**FLORIDA POLYTECHNIC UNIVERSITY
UNIVERSITY PROCUREMENT
LAKELAND, FL**

**ITB 23-068
CHILLED WATER EXTENSION PROJECT**

DATE: 04/04/2023

ADDENDUM NO: Two (2)

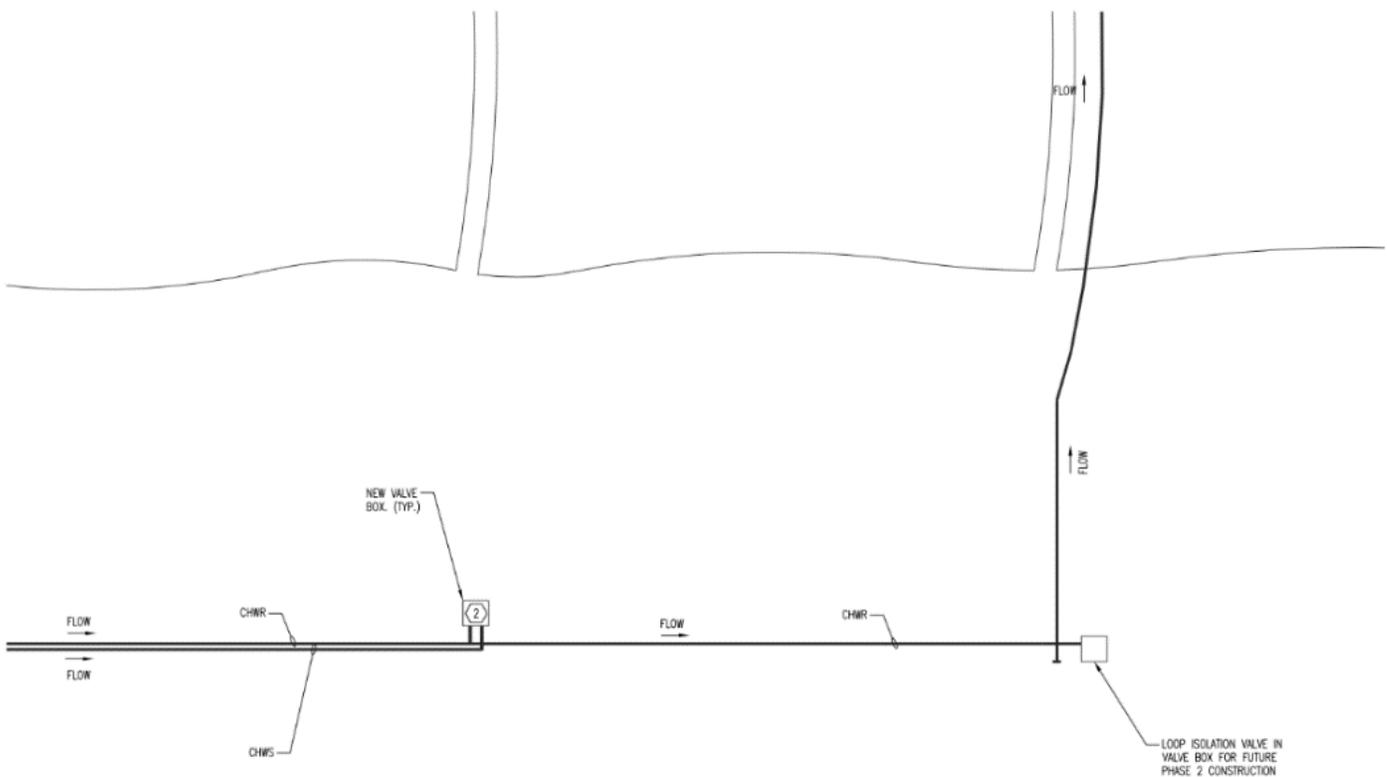
- It is our understanding from the civil as-built drawing below, that the existing chilled water supply is a 6" pipe that turns 90 degrees into the vault. This drawing is from 2012 when the campus was built and is believed to be an accurate representation of the as-built conditions.

- We have confirmed with the engineers that the new extension could be tied into the existing supply line through the valve located in the vault where the extension will tie into the system. A “T” should be utilized at the valve to allow a tie-in for a future building at that location. The new line would then be routed back around and into the pathway of the existing return line heading south. This is in lieu of hot tapping a “T” in-place of the elbow to extend the supply line. Both are considered viable solutions for the purposes of this ITB.

- The new supply pipe will need to run under the walkway adjacent to the vault where the pipe terminates. The removal and restoration of this walkway should be included in the scope of work.

VALVE BOX DETAIL
No Scale

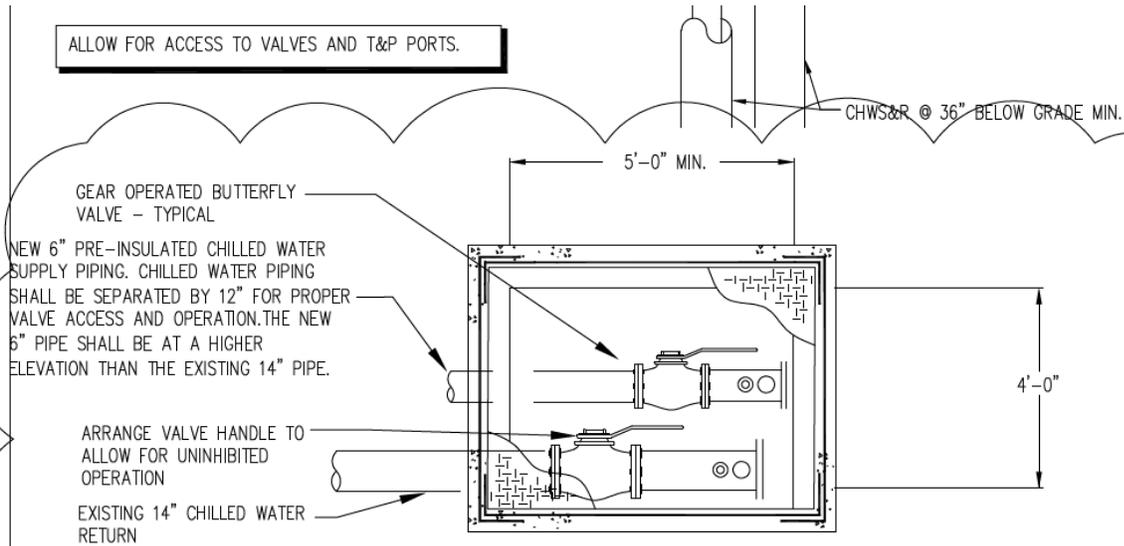
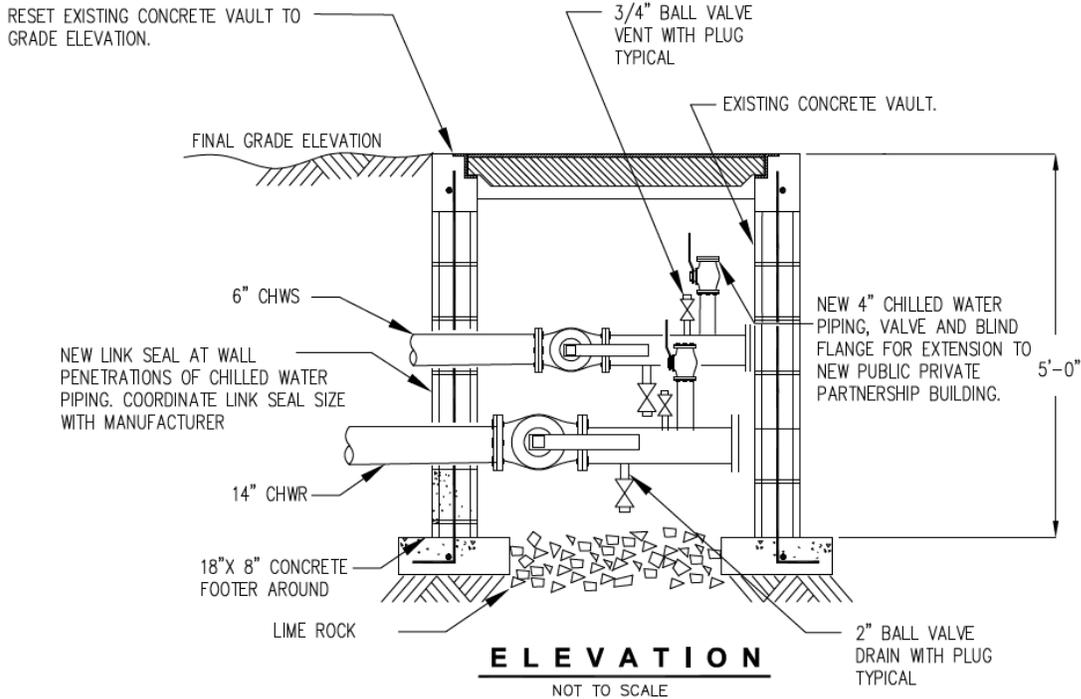
- The existing vault should be large enough to support the addition of the 6” supply in addition to the 14” return line that is existing, see this revised drawing from the engineers to illustrate the offset location of the two lines to allow clearance.

ALLOW FOR ACCESS TO VALVES AND T&P PORTS.
